April 2016 Contingency Use Requests

CALEB DUSTIN HUNKING MIDDLE SCHOOL SCHOOL BUILDING COMMITTEE MEETING

MEMORANDUM

To: Kathleen Smith, City of Haverhill
 From: William G. Cunniff – NV5
 Date: April 26, 2016
 Re: GMP & Construction Contingency Approval: Caleb Dustin Hunking School
 Cc: James F. Scully; Jeffery Luxenberg; Adam Sniegocki

RFI-291

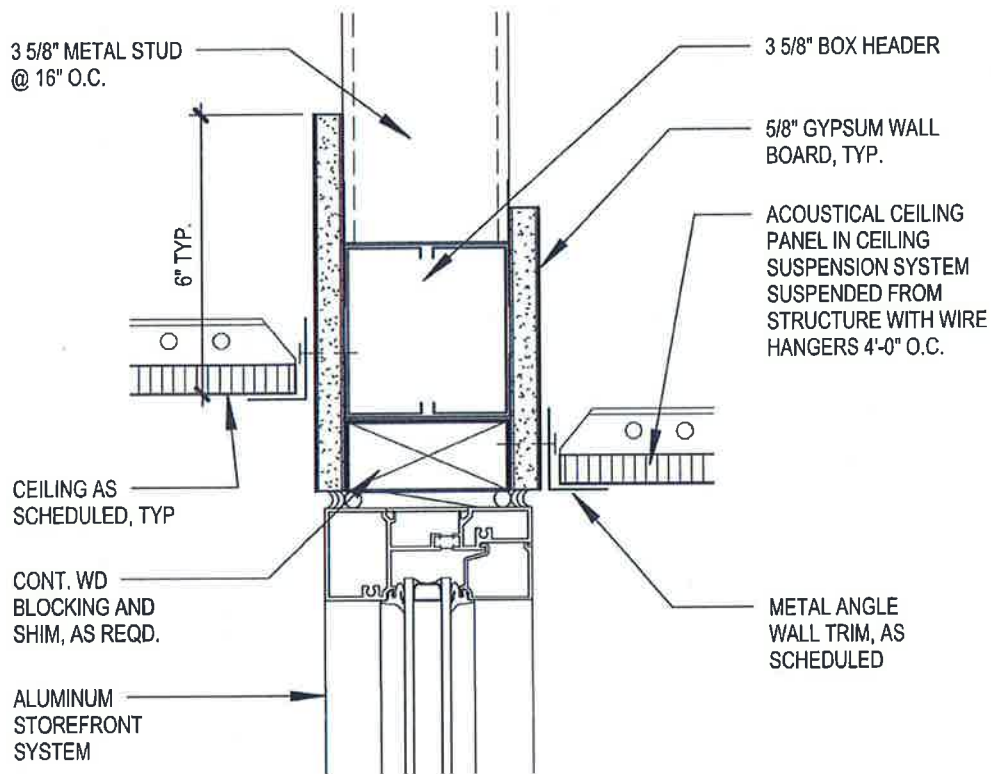
Interior storefront vestibules SI-19, SI-20 and SI-21 go from floor level up to ceiling and do not show a wall or any type of framing above. Please provide a detail for framing above these storefronts.

1 MEDIA CENTER SOFFIT

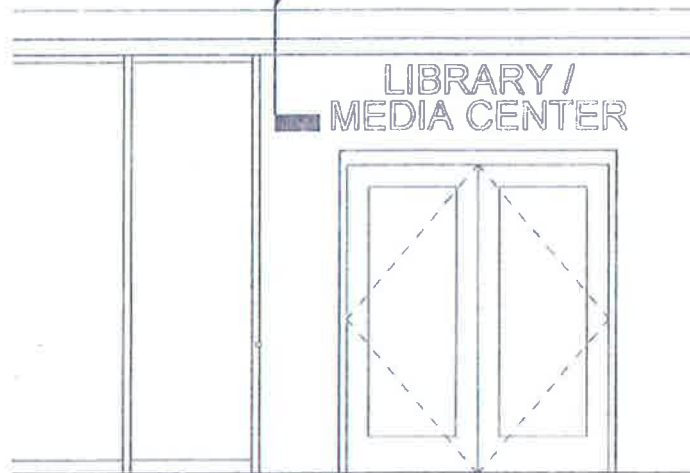
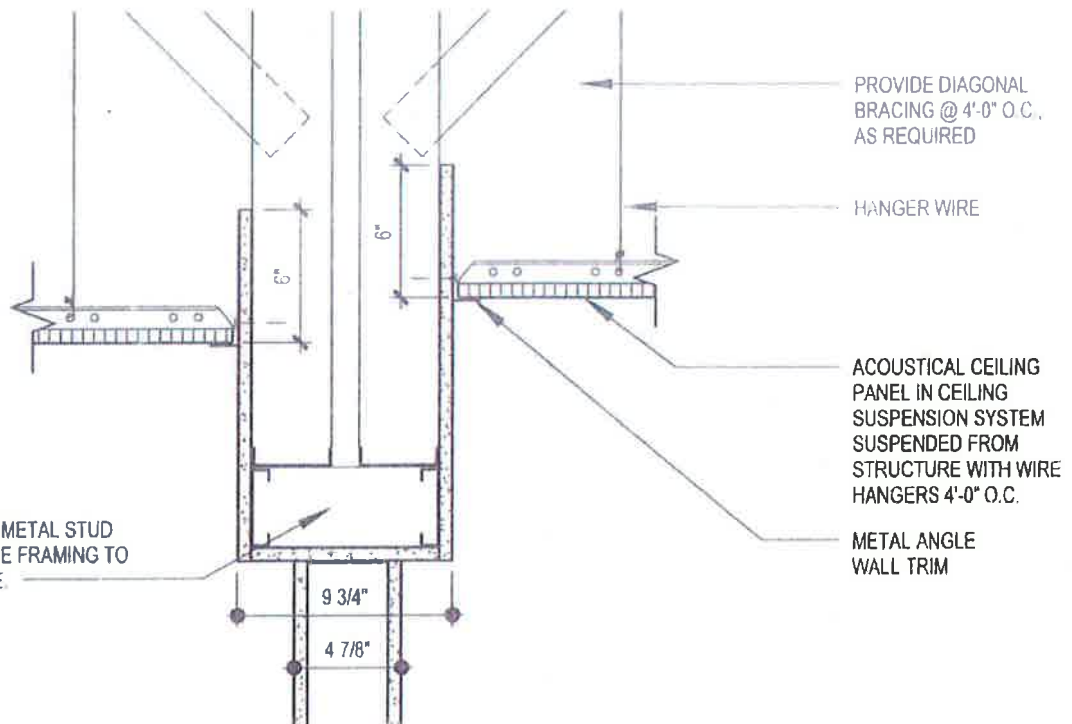
Question Please see the attached marked up shop drawing for the folding glass partition support. Currently the top of the head for the folding glass partition (at the media center) will be installed at 9'-6". The angles for the glass partition supports will be exposed, a soffit will need to be constructed to cover up these support angles per the attached sketch (soffit is shown in blue). Please confirm this is acceptable.		Date Required: January 19, 2016	
Suggestion

Answer Kickers should be shifted up to connect above 10'-6". Structural has agreed to this modification - please resubmit shop drawings for this change. See SK-030 for soffit detail KKL 01/28/16		Date Answered:	
Cc: Company Name		Contact Name

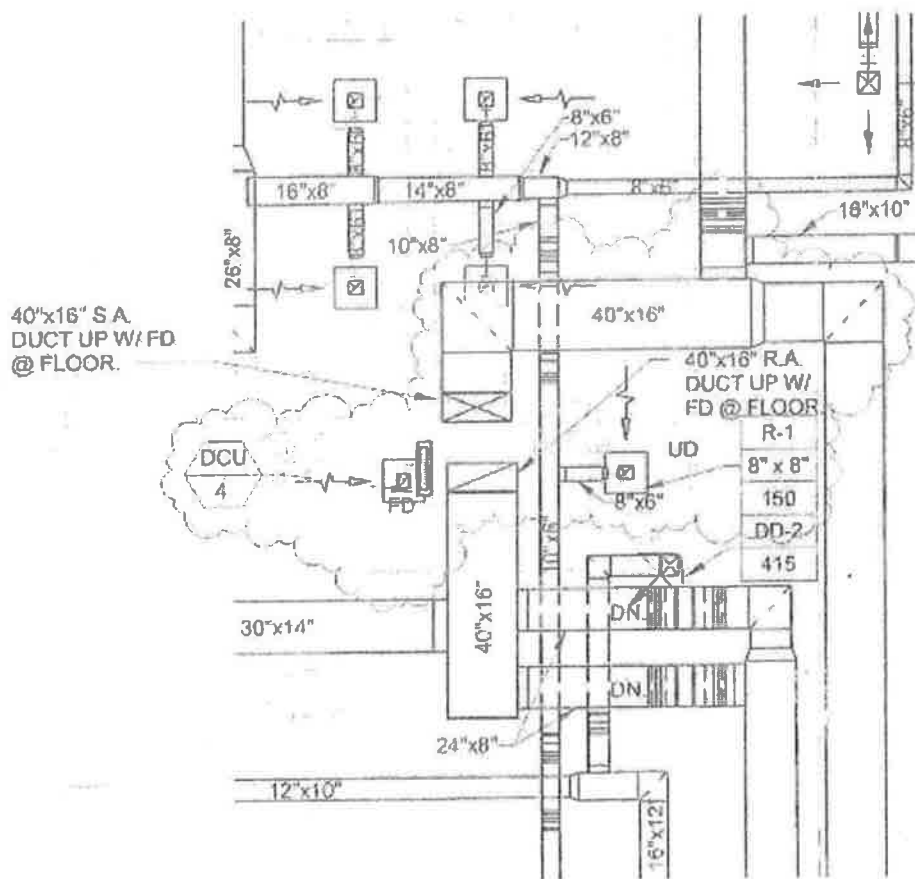
Electrical code calls for a 6' clearance above the top of electrical panels to any kind of piping or duct located within that room. There is a duct drop located within room C138A which cannot be relocated to another room. This duct is within the required 6' clearance above the top of the electrical panel. Code would allow this if a structural ceiling is built within this room. Please advise if it is acceptable to build a gypsum board ceiling within this room at an elevation of 8'-4".

Move ductwork per response to RFI 221 and SK-025, attached.

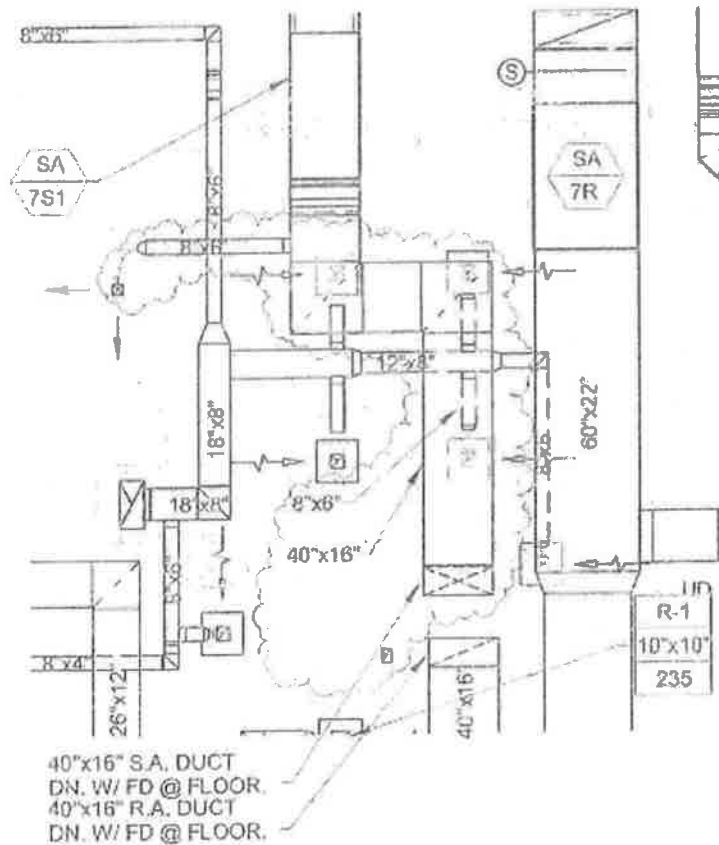
Electrical code calls for a 6' clearance above the top of electrical panels to any kind of piping or duct located within that room. There is a duct drop located within room C138A which cannot be relocated to another room. This duct is within the required 6' clearance above the top of the electrical panel. Code would allow this if a structural ceiling is built within this room. Please advise if it is acceptable to build a gypsum board ceiling within this room at an elevation of 8'-4".

1 WORKROOM A221 REVISED
1/8" = 1'-0" TYPICAL AT WORKROOM A321

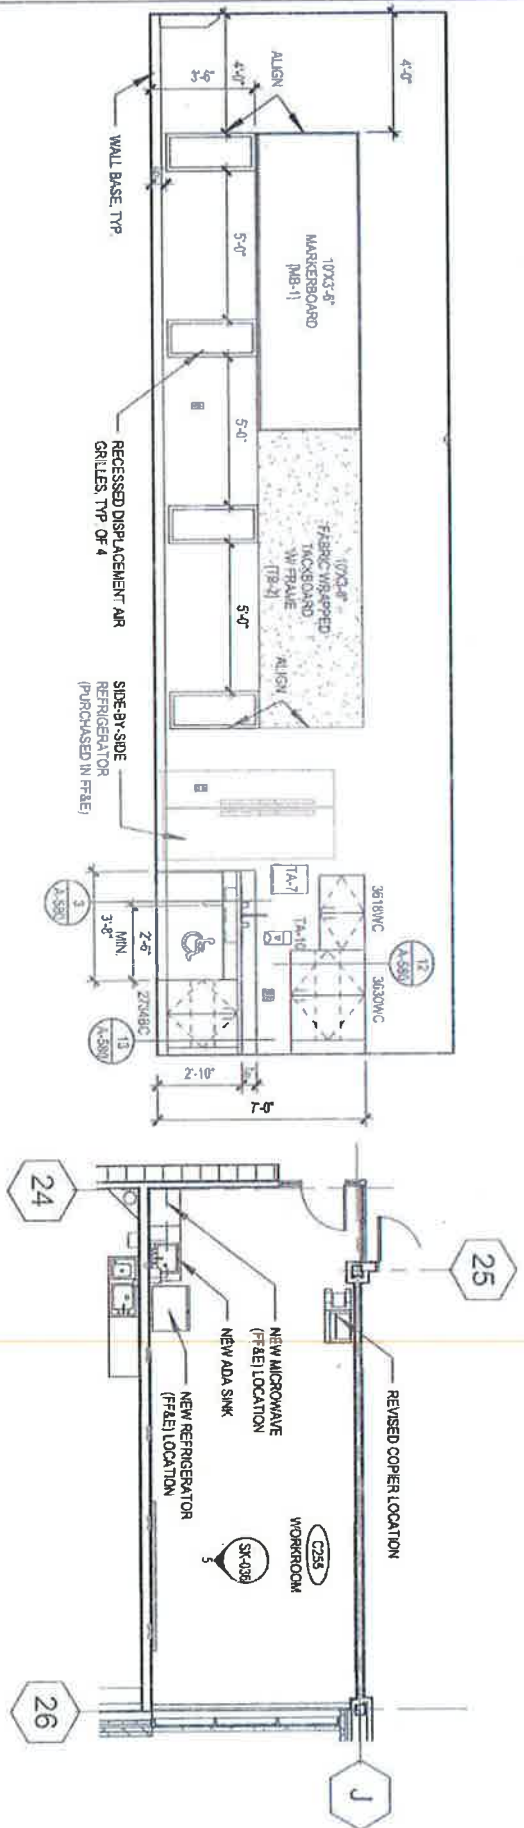
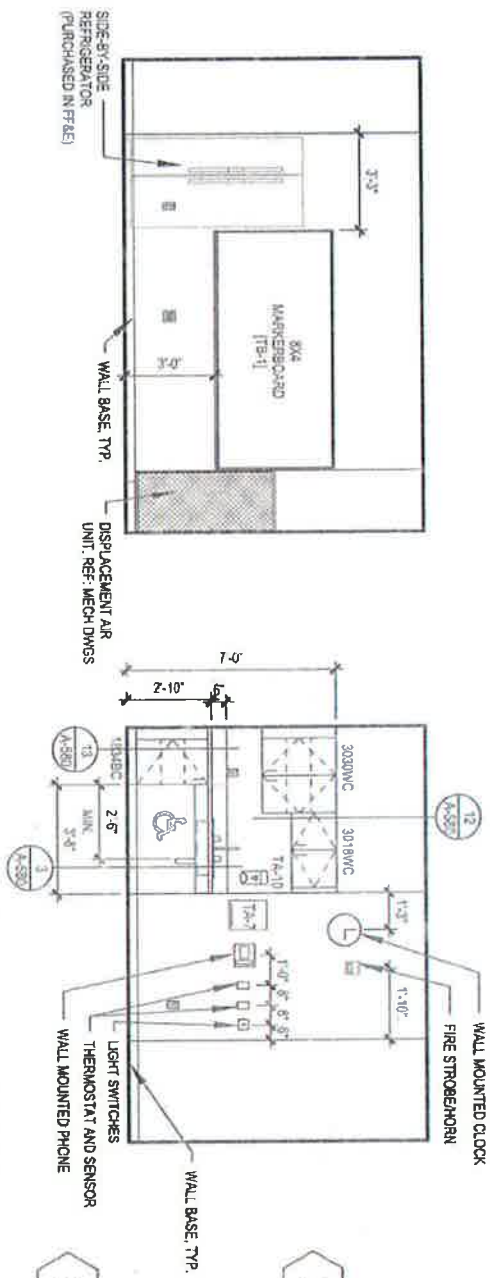
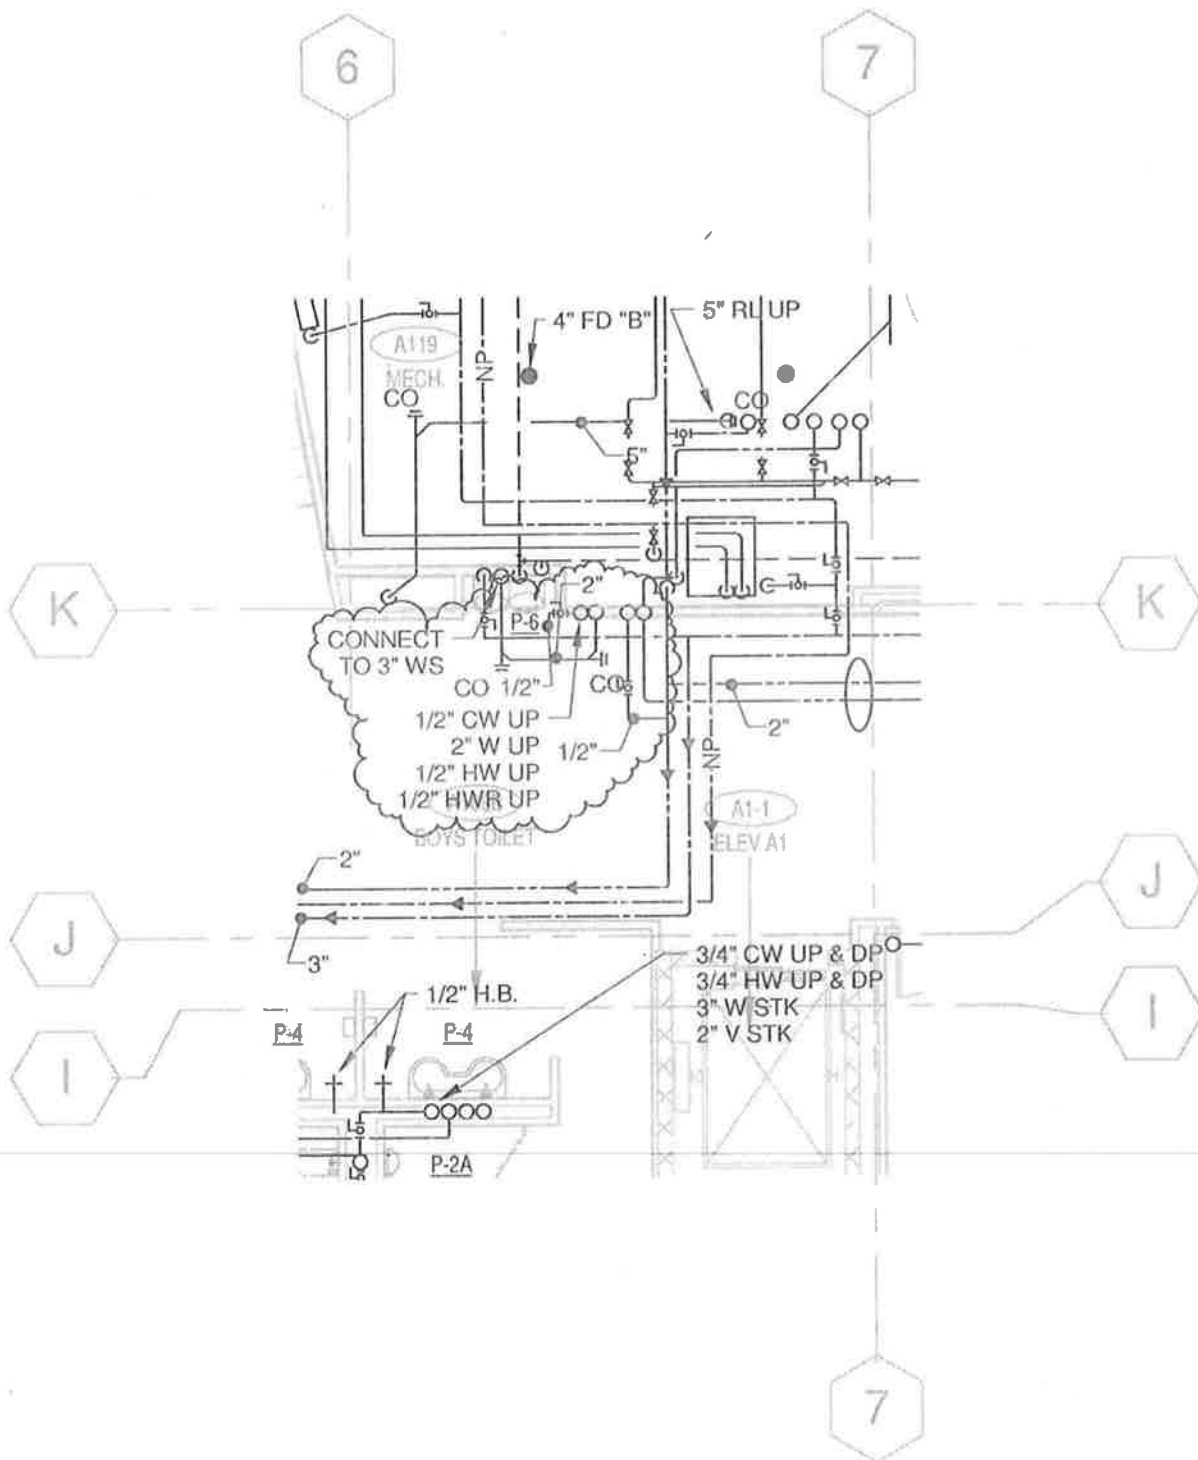
Add sinks at three (3) workrooms per CCD-011 - Description of Work	Value \$
Issued by JCJ, CCD-011 details the addition of sinks/casework to three (3) workrooms. This work was not shown on the construction documents, but it was determined to be necessary by HPS, so the rooms could function as originally intended.	\$ 19,318.00
	\$ 19,318.00

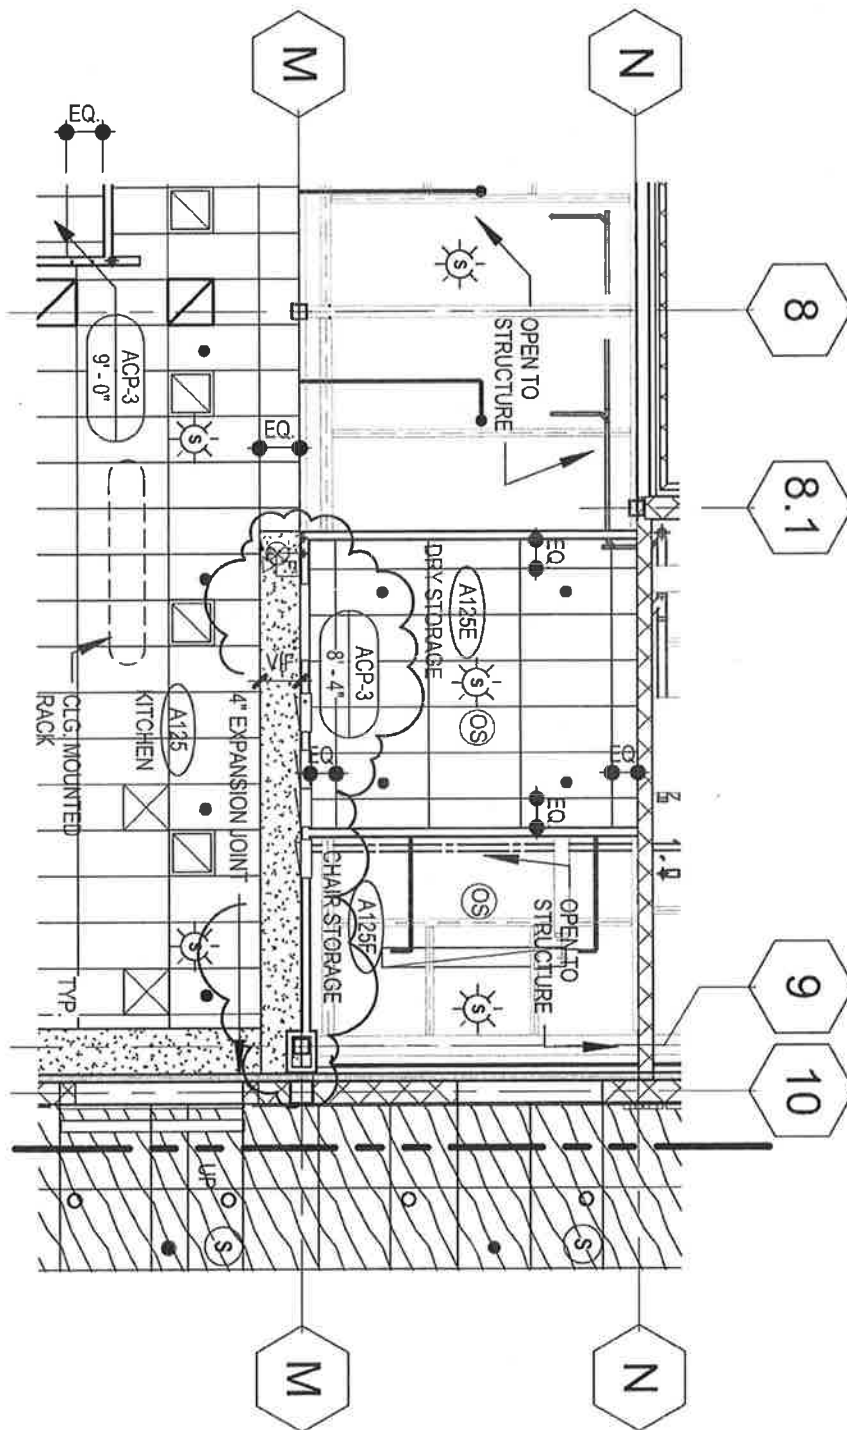
1. Lower ceiling in A125E to 8'-4".
 2. Add soffit as shown in SK-042 attached. Width to be as narrow as possible - VIF.
 3. Acceptable as shown.
- KKL 02/29/16

2 STAIR DETAIL @ LOWER LANDING, TYPICAL
 1 1/2" = 1'-0"

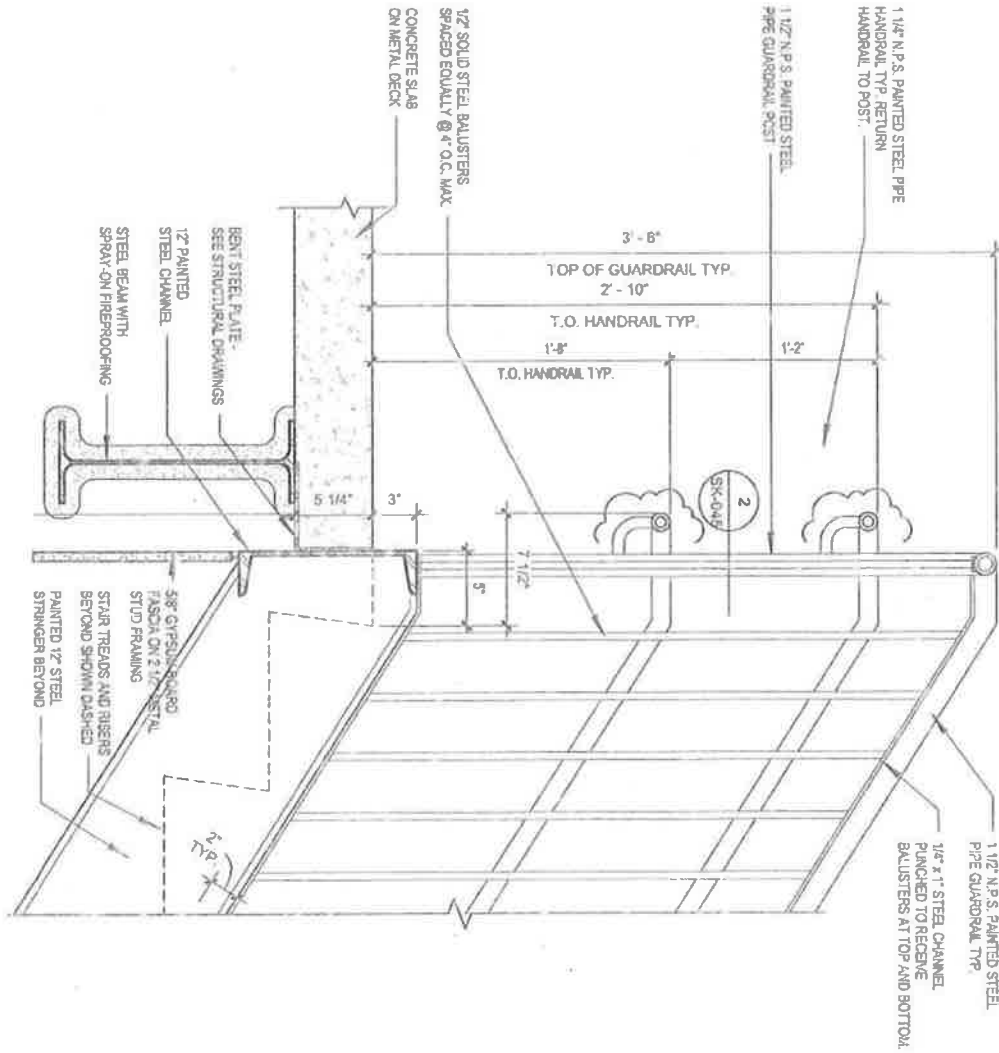
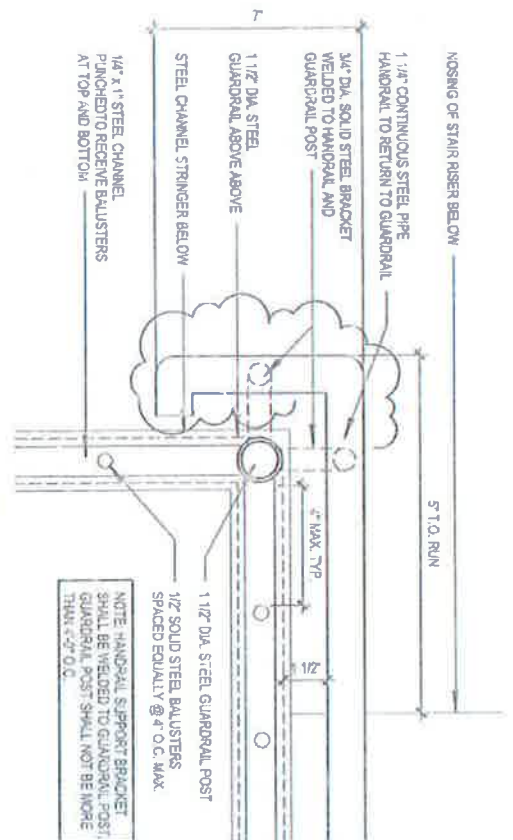
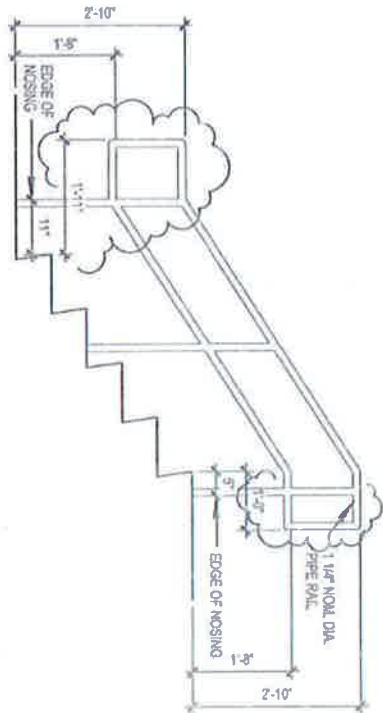
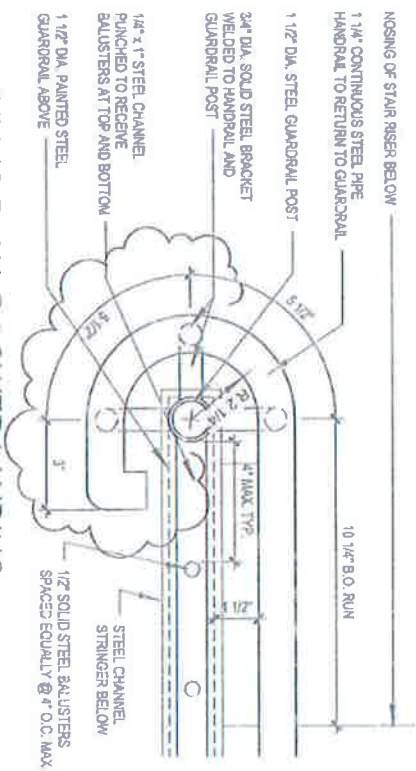
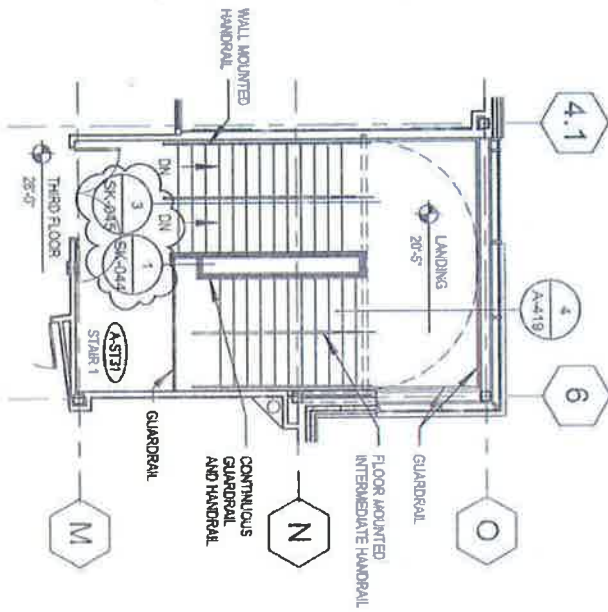
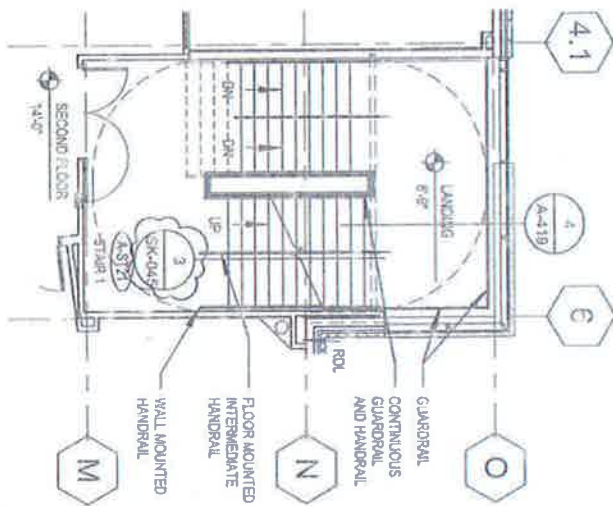
Revise handrails at stairs 1, 2, 4, & 5 per CCD-015 - Description of Work	Value \$
Issued by JCJ, CCD-015 details the revision of handrails at stairwells 1, 2, 4 & 5. These code required ADA revisions, requiring extension of stairwell handrails, were not shown on the construction documents.	\$ 18,316.00
	\$ 18,316.00
